Re: Permit P40776, Macedon Cross (H1027) – Response to RFI

Further to the Request for Further Information received on 03 March 2025, please see the below responses.

Dulux Shale Grey

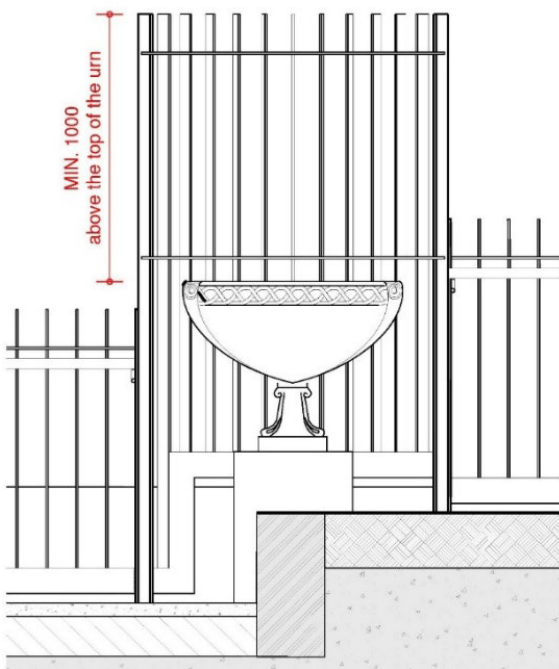
3. *Details on the paint finish to the proposed new balustrade. Drawing number 22060.00 refers to a paint specification, however these details are unable to be located on either the drawings or in the Heritage Impact Statement.*

Please find attached the details of the paint specification.

The paint colour is to be a grey to matches the colour of the gum tree trunks, similar to the existing balustrade, in order to visually blend into the background of the forest. The colour will be Dulux Shale Grey or similar. The exact shade is to be determined on site to achieve the lowest visual impact.
